COUNCIL REPORT

Date: 11 February 2016
File: 7.5.3.127
To: Warren Waycheshen, CAO for Mayor and Council
From: Director of Community Planning & Development
Re: **Riverbrook Estates Zoning Amendment Bylaw No. 1878**

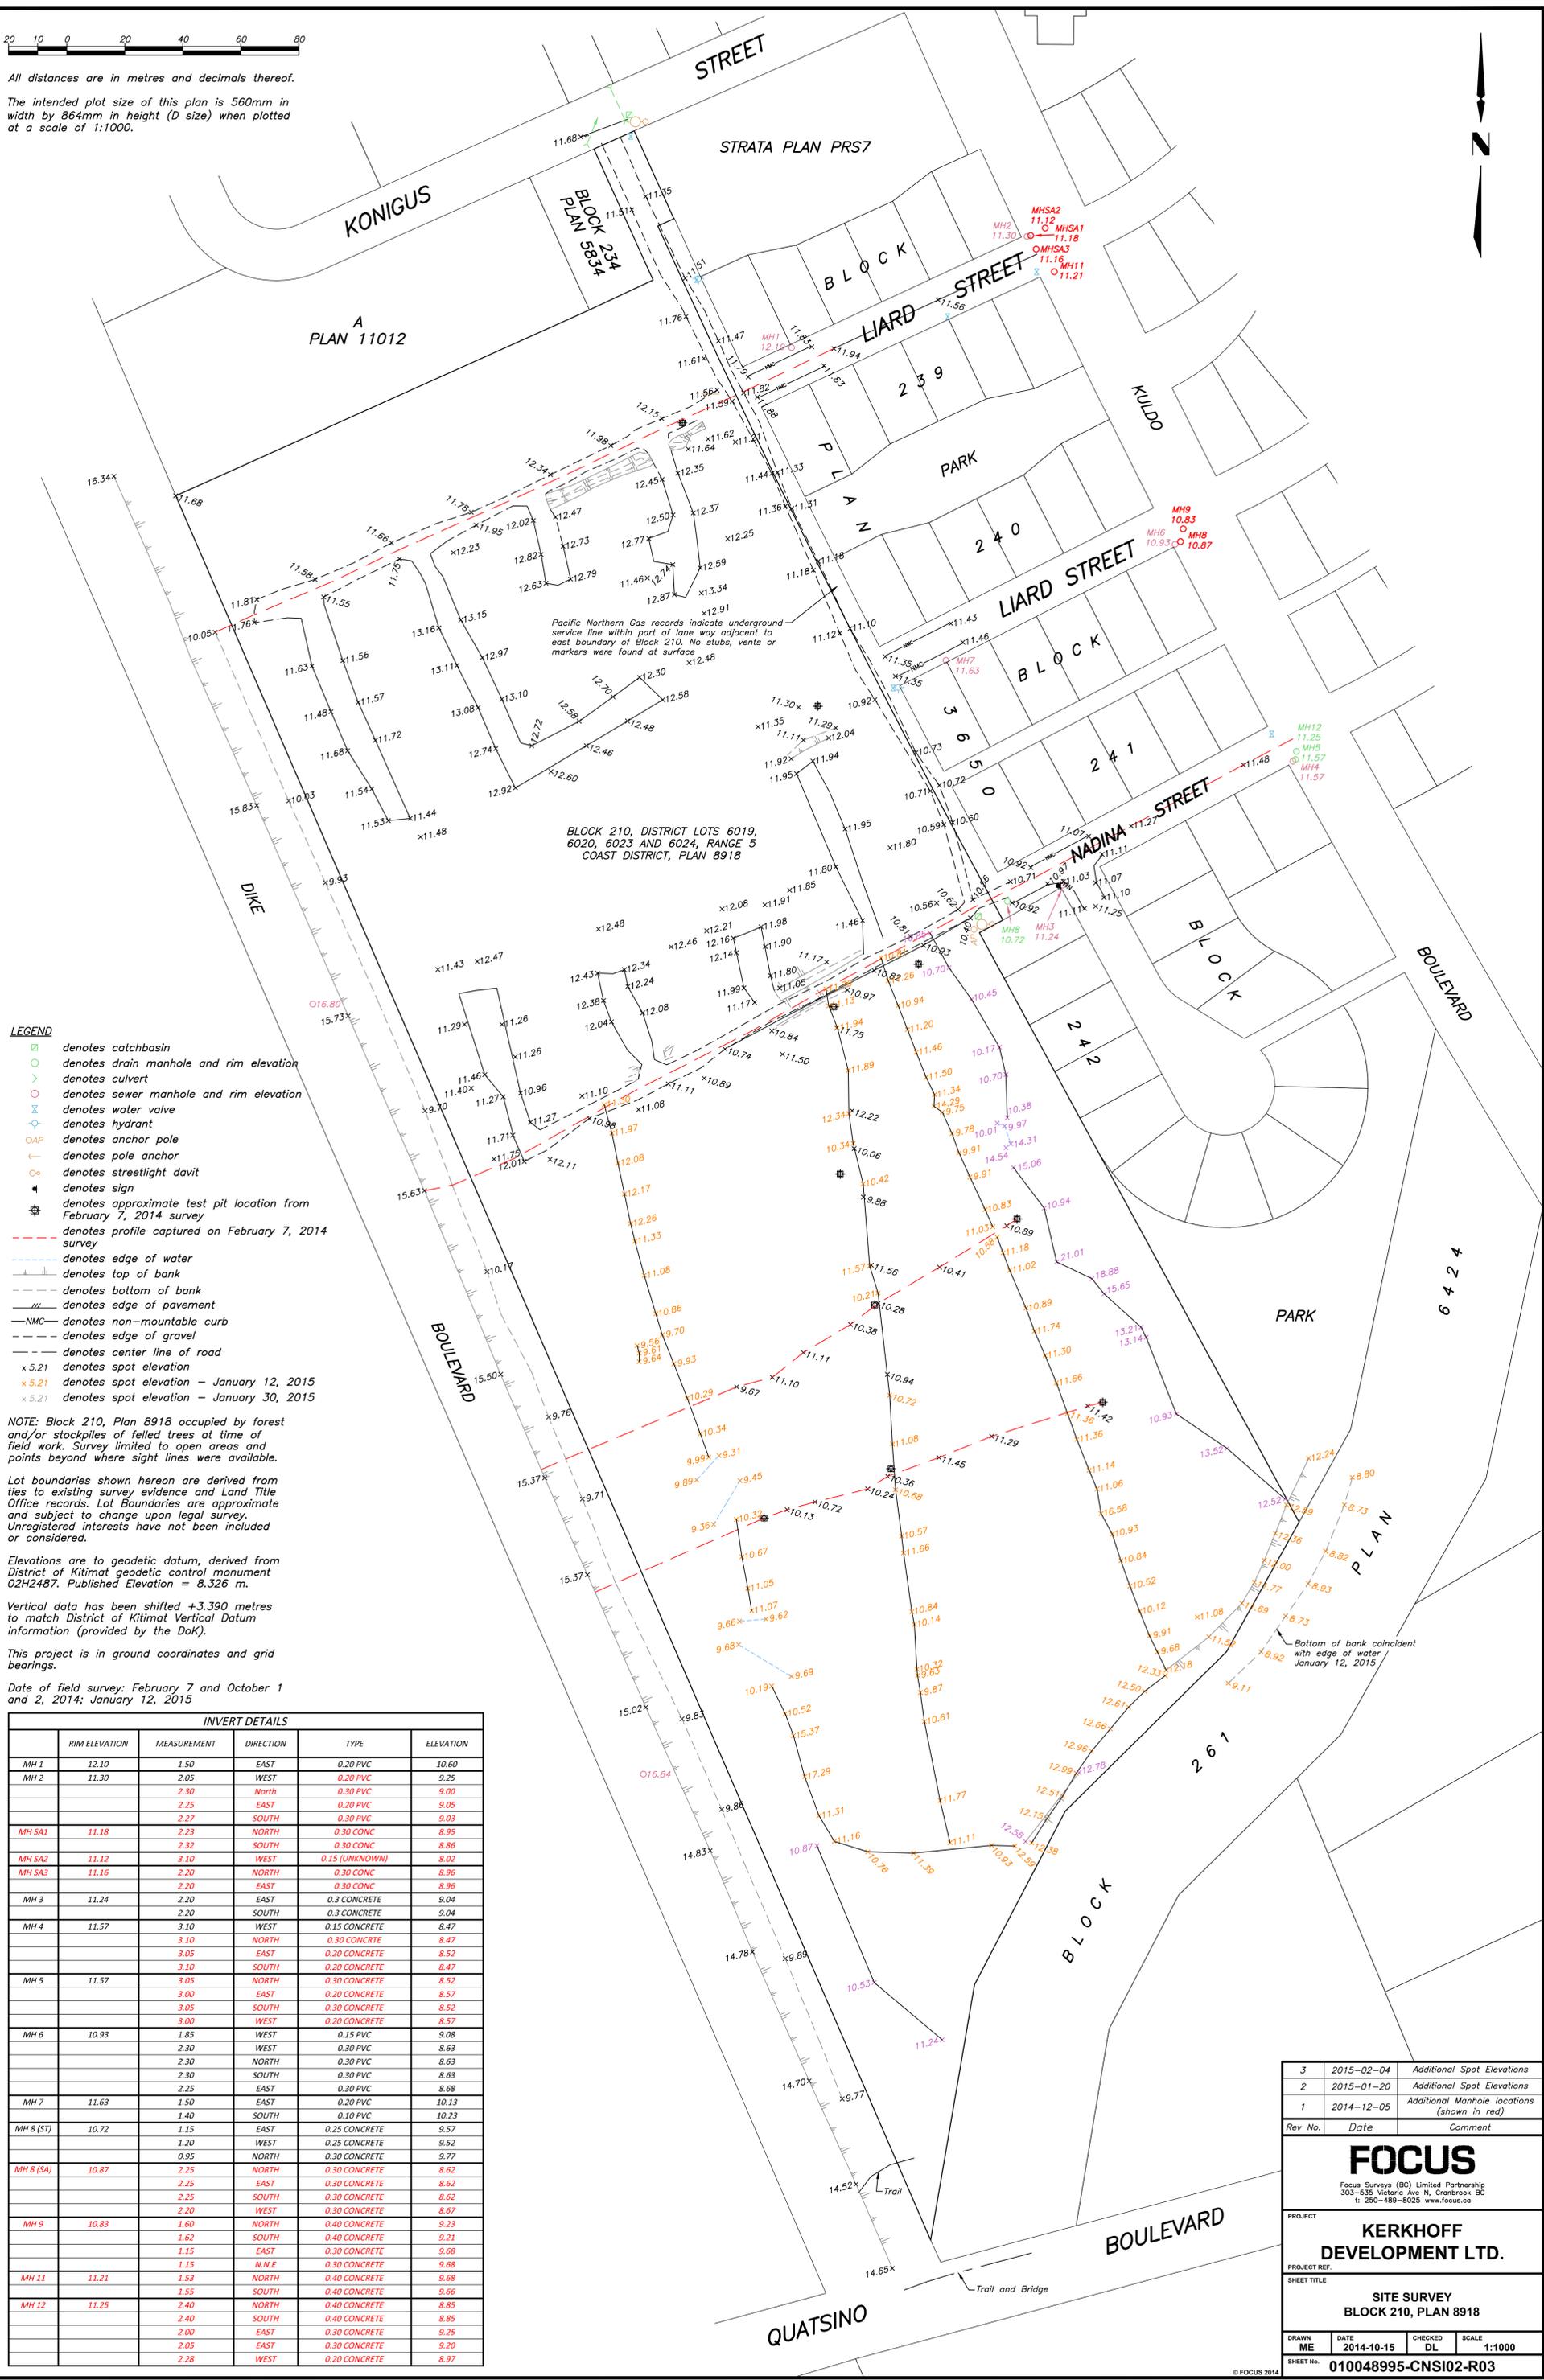
4. MoE/MFLRNO comments only address river and not the creek. Have those setbacks been taken into consideration?
Current site plan shows the property being 30.00m from Sumgas Creek. The Site Survey shows a spike in elevation along Sumgas Creek from ~8.8m to ~12m and then slopes down to ~9m on the site. We are hoping to see what the elevational difference will be from the creek to the site and if there is a greater risk of flooding from that side.

Water levels of Sumgas Creek have been monitored for nearly a year to determine the seasonal fluctuations. See attached table[s]. The developed area would be re-graded/filled to somewhere in the order of 10.00m or higher, while the creek just reaches 9.09meters. These details are engineering details that are sorted out as part of servicing agreements, etc.

Random water surface elevations taken over a 9 month period are not statistically significant in predicting design storm flows in this area. Several areas in Kildala Neighbourhood, including the Liard area, were subject to local flooding in the 1980's. During a municipal survey and investigation of the problem areas the water surface elevations in the Kildala Drainage Channel (since named Sumgas Creek) just east of the proposed re-zoning were recorded at 9.5 metres. Groundwater elevations in excess of 10 metres were also recorded in the Park area behind Liard Street. After studying the problem and modelling for various return period storms permission was granted to undertake excavation to remove accumulated siltation from Sumgas Creek to reduce the design flood level. However, as this work was undertaken over 20 years ago project development should be based on design road elevations not less than the existing Nadina Street elevation unless further study demonstrates a lower elevation will not result in local flooding.
